Board identification

This errata sheet applies to the X-NUCLEO-CCA02M1 digital MEMS microphones expansion board based on MP34DT01-M for STM32 Nucleo. The full list of part numbers is shown in the table below.

1.1 Oversized ST Morpho connector

Figure 2. Correct mounting

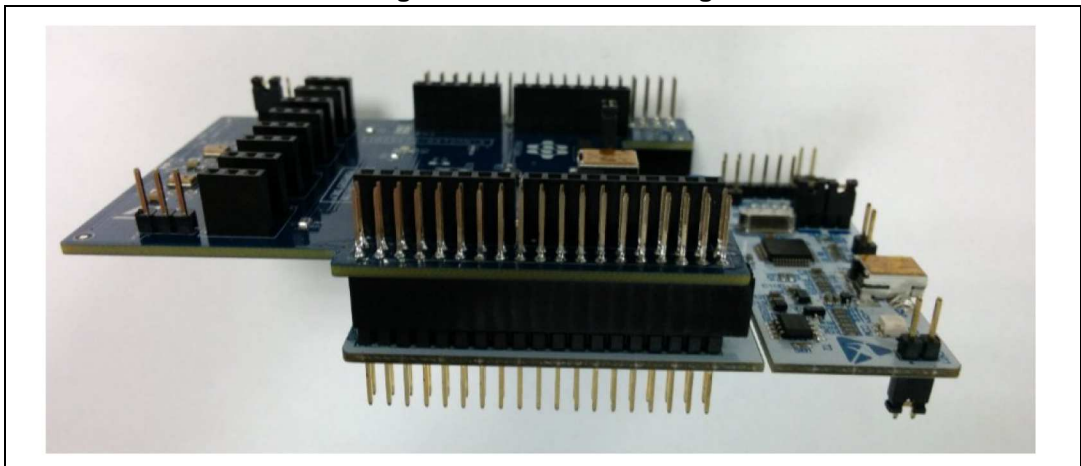
These boards mount a 2 x 20 ST Morpho connector instead of the 2 x 19 one. It could cause incorrect alignment of this board on the STM32 Nucleo.

The workaround is to carefully mount the X-NUCLEO-CCA02M1 over the STM32 Nucleo board and verify they are aligned as in [Figure 2](#) before supplying power to the boards.
